Product Change Notification: CBOL-24ZMOX279

CCB 8247 Final Notice: Implement new carrier tape design for ATXMEGA64A1-AUR, ATXMEGA128A1-AUR, ATXMEGA128A1U-ANR, ATXMEGA128A1U-AUR, ATXMEGA64A1U-AUR, ATXMEGA128B1-AUR, ATXMEGA64B1-AUR, ATMXT768E-ABR026, ATMXT540E-ABR-A21, ATMXT768E-ATR, ATMXT540E-ATR, ATUC3T-ATR, ATMXT540E-ATR-A0, ATMXT540E-ATR-A1, ATUC3T-ATRV01, ATMXT540E-ATRV02, ATMXT540E-ATRV03, ATMXT540E-ATRV05, ATMXT540E-ATRV07, ATSAM4LC8CA-AUR, ATSAM4LS8CA-AUR, ATSAML22N16A-AUT, ATSAML22N17A-AUT and ATSAML22N18A-AUT catalog part numbers (CPN) available in 100L TQFP (14x14x1mm) package at ASE9 final test site.

Pre and Post Change Summary – 100L TQFP 14x14x1.0mm

Carrier Tape Comparison

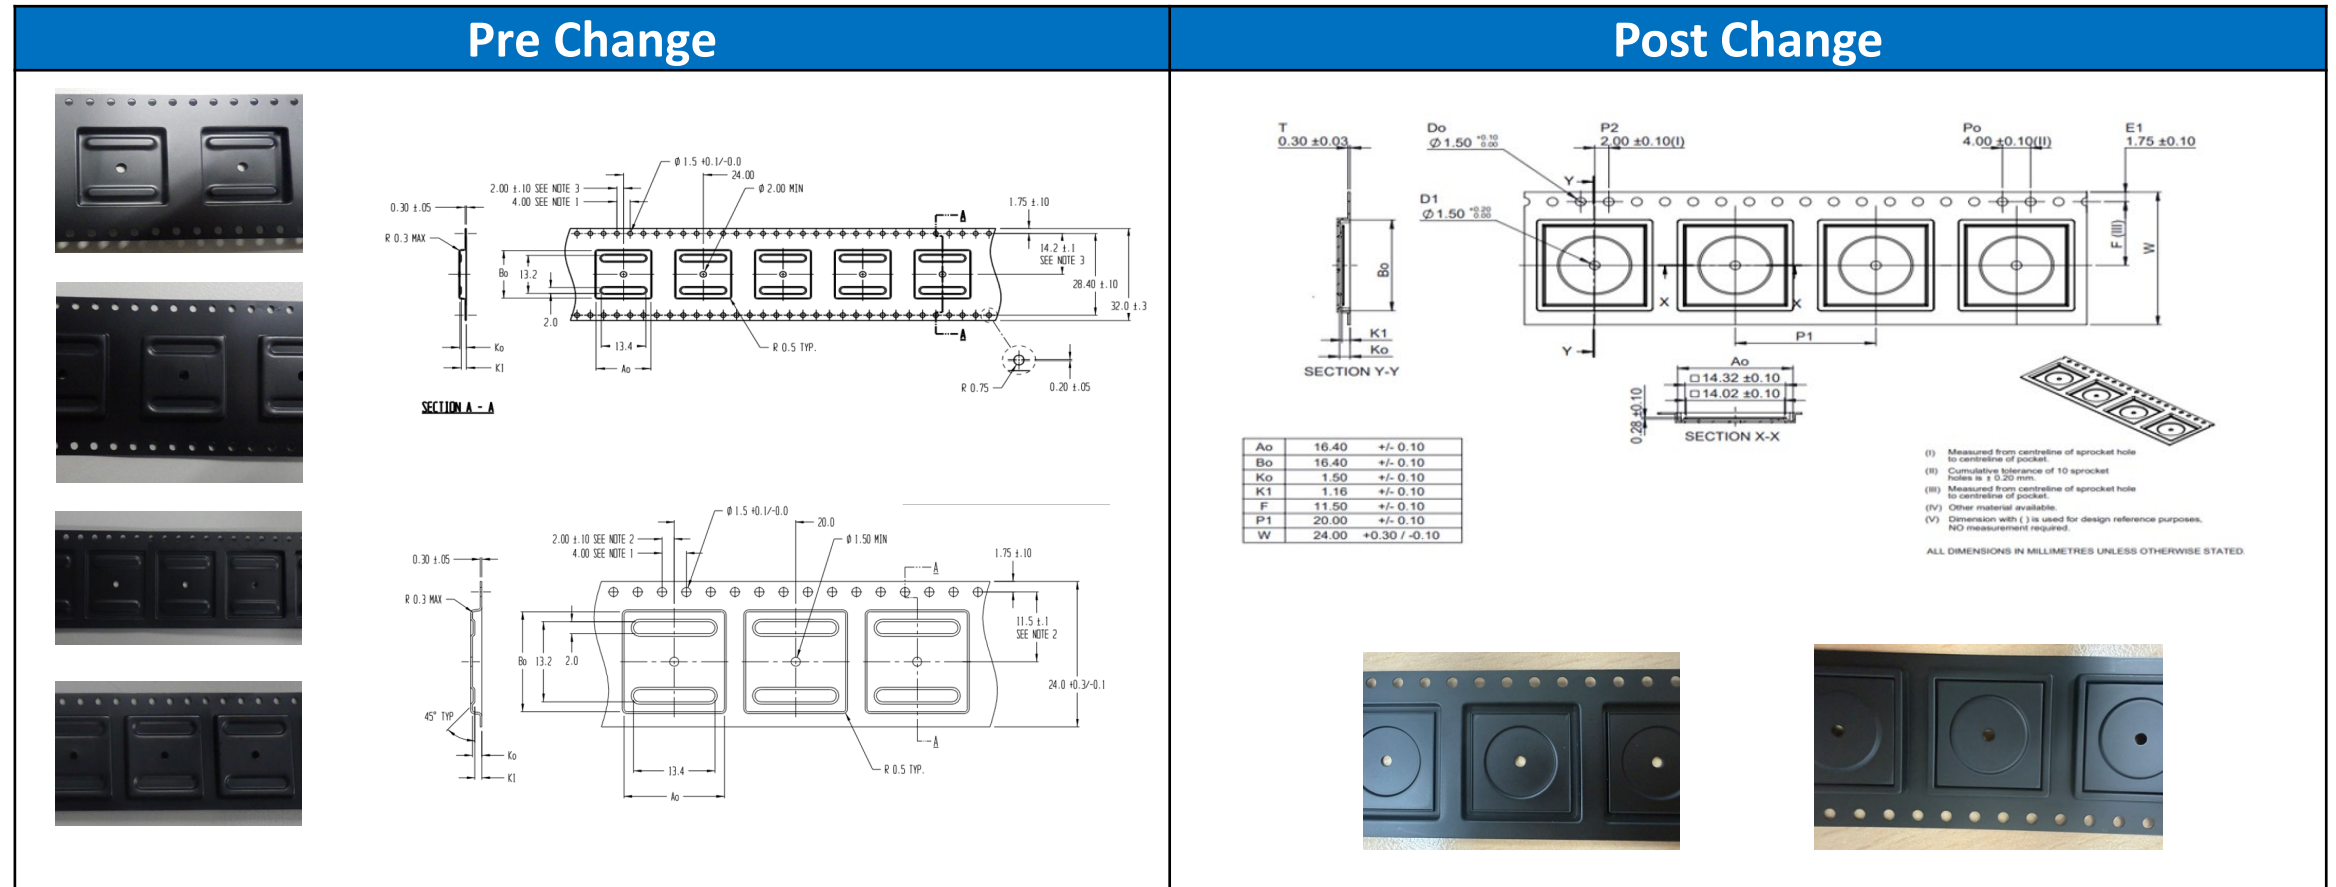
Condition	W (mm.)	P (mm.)	A0 (mm)	B0 (mm)	K0 (mm)	K1 (mm)	Thickness (mm)
Pre-Change	32.0±0.3	24.00±0.1	16.50±0.1	16.50±0.1	1.90±0.1	1.55±0.1	0.30±0.05
Pre-Change	24.0+0.3/-0.1	20.00±0.1	16.50±0.1	16.50±0.1	1.55±0.1	1.20±0.1	0.30±0.05
Post-Change	24.0+0.3/-0.1	20.00±0.1	16.40±0.1	16.40±0.1	1.50±0.1	1.15±0.1	0.30±0.03
